Planning Board
Planning and Urban Development Department
Planning Division
City of Portland
389 Congress St
Portland, ME 04101

Re: 30 Merrill Street

October 4, 2016

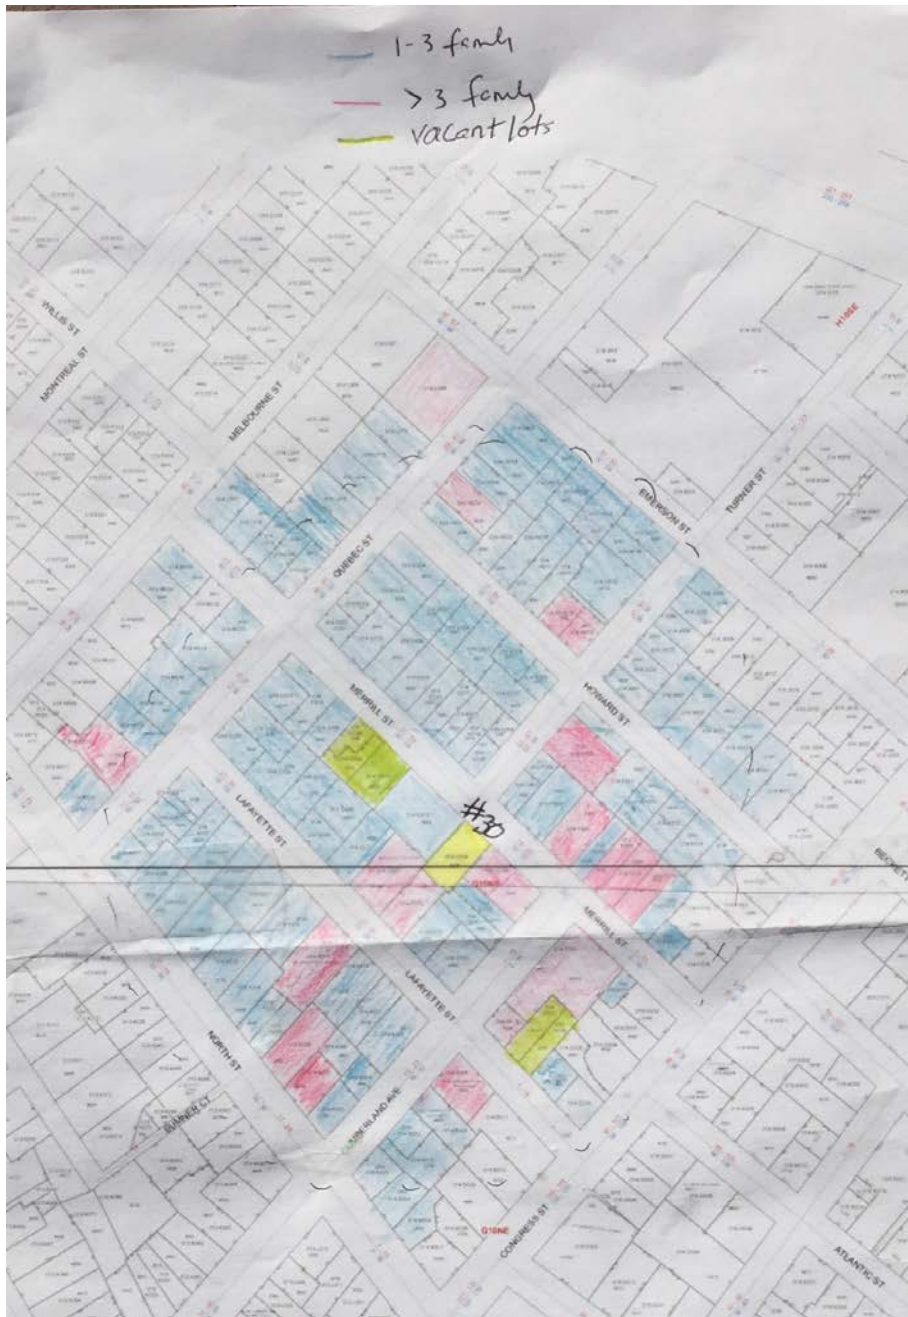
This building does not in any recognizable way reinforce positive features of the surrounding area. Within the block the unique identity of the large buildings to the south are their bays and cornices and mansard roofs, to the north, for the smaller residence are their gable ends, their bays, window shapes and emphasized entrances. It is not impossible to design a larger building that is sympathetic to an existing neighborhood of smaller residences. An excellent example is the new 5-family building at 72 Munjoy Street. Although it is the largest building on the street it, it does not overwhelm the neighborhood; rather, it adopts numerous of the existing characteristics of its neighborhood and employs them in its design.

As for the balconies that the architect relies on heavily to satisfy the B-5 façade articulation standard (this because no other of the architectural elements of facade articulation exist: no gables or dormers, no recessed entry, no bay windows, and surely the small awning over the entry does not constitute a “covering”), the railings across the sliding doors used as windows do not in any way read as balconies and if they are also designed “pay homage to the traditional bay window,” (a two’fer? balcony and bay?) they have missed the mark by a long shot. And does not Standard D-3 state that balconies must be a minimum of 6 feet in depth? What is presented to the Board as a balcony (or bay) in an attempt to satisfy the facade articulation standard in fact neither actually articulates the building nor does it create an impression of articulation. The most recent iteration has created an indentation running from the ground to the 3rd floor along the vertical line above the “front door.” Although it is an improvement to my eye, it is inadequate to satisfy the articulation standard.

Most definitely, when considering design, size matters. The bigger the project, the bigger the impact of the design, the bigger the effect on the neighborhood. The architect argues that the proposed building has massing and roofing much like the double-wide triple decker buildings “that exist throughout the neighborhood.” I believe he is referring to the three large multi-families towards Congress Street on Merrill and the several nearby on Cumberland Ave. Otherwise, I can find no double-wide triple deckers in a 2-block radius. There are a few two-entrance buildings, but no double wide triple deckers which seems reasonably interpreted to mean this:

Design Standard C-1 states: "Emphasize and orient the main entrance to the street." The 30 Merrill design includes a minimally-enhanced "main entrance," which we learned at the neighborhood meeting is not a main entrance at all. In fact, it is an entrance to the basement that contains only storage areas for the units. It seems to be the argument that so long as it looks like a main entrance that is enough. It is not. There is a rationale behind this design standard that has been well articulated by numerous urban designers (Jan Gehl , Cities for Real People; Jane Jacobs, The Death and Life of Great American Cities; Christopher Alexander, A Pattern Language), planners and articulated in municipal standards. The rationales relate to the life of the street, community, walkability, and the safety of the inhabitants and passersby.

One of the reasons the building looks so out of place in the rendering is the size and horizontal effect of the front windows. The windows are in fact two sets of sliding doors put together and the net effect is a window of 11'10"H x 6'9 ¾"W, most definitely horizontal in effect. Again, there is nothing like this on Merrill Street. This design fails to recognize and be responsive to the patterns and characteristics of the buildings of the neighborhood. In addition, it ignores the design standard relating to windows (D-1), which states that the majority of windows shall be vertically proportioned, and encourages classic proportions. These grouped sliding doors are neither. In addition, it is startling to see first floor windows of this size. They would be appropriate for a commercial space, but despite being 48" from the ground are not in keeping with a first floor living space and again fails to find any sympathy with the predominant design features of the neighborhood. Where such large windows do exist on Congress Street they are all office and retail spaces, not residential.
